Access Compliance Report

Public Rights-of-Way

Intersection ID: 3041	Main Street: BROWNE_RD	Cross Street: WHITE_STAG_DR	Location: W
ADA ID: 0FC5A727A279	Ramp Type: Perp	Initial Pass/Fail: Fail	Overall Compliance: No
Severity Score: 21.25			
Codes/Mitigation Info/Possible Solution		Field Measurements/Component Compliance

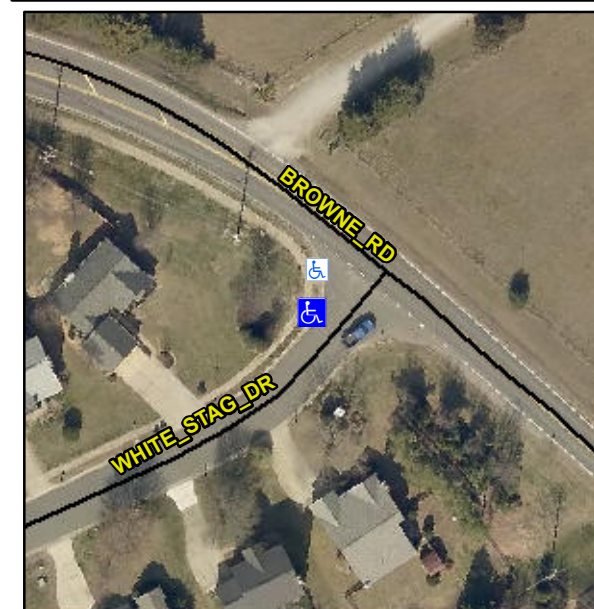
R304.5.1, R304.2.2

Compliance	Description	Data	Compliance	Description	Data
N/A	Ramp Length (in)	48.0	No	Ramp Slope (%)	10.5
No	Ramp Width (in)	44.0	Yes	Ramp XSlope (%)	1.7
N/A	Flare Type LT	N/A	N/A	Flare Type RT	N/A
N/A	Flare Slope LT (%)	N/A	N/A	Flare Slope RT (%)	N/A
N/A	Flare Traversable LT?	N/A	N/A	Flare Traversable RT?	N/A
N/A	Landing Length (in)	N/A	N/A	DWS Provided?	N/A
N/A	Landing Width (in)	N/A	N/A	DWS Contrast?	N/A
N/A	Landing Slope (%)	N/A	N/A	DWS Length (in)	N/A
N/A	Landing X Slope (%)	N/A	N/A	DWS Full Width?	N/A
N/A	Landing Curb? (Y/N)	N/A	N/A	DWS Offset (in)	N/A
N/A	Shared Landing?	N/A			
N/A	Gutter Ponding?	N/A	N/A	Gutter Slope (%)	N/A
N/A	Gutter Lip Ht (in)	N/A	N/A	Gutter X Slope (%)	N/A
N/A	Painted X Walk1?	No	N/A	Painted X Walk2?	N/A
	X Walk 1 Direction	To SE		X Walk 2 Direction	N/A
N/A	X Walk 1 Width (in)	N/A	N/A	X Walk 2 Width (in)	N/A
	X Walk 1 Slope (%)	0.6		X Walk 2 Slope (%)	N/A
	X Walk 1 X Slope (%)	1.6		X Walk 2 X Slope (%)	N/A

Remove & Replace Entire Ramp.
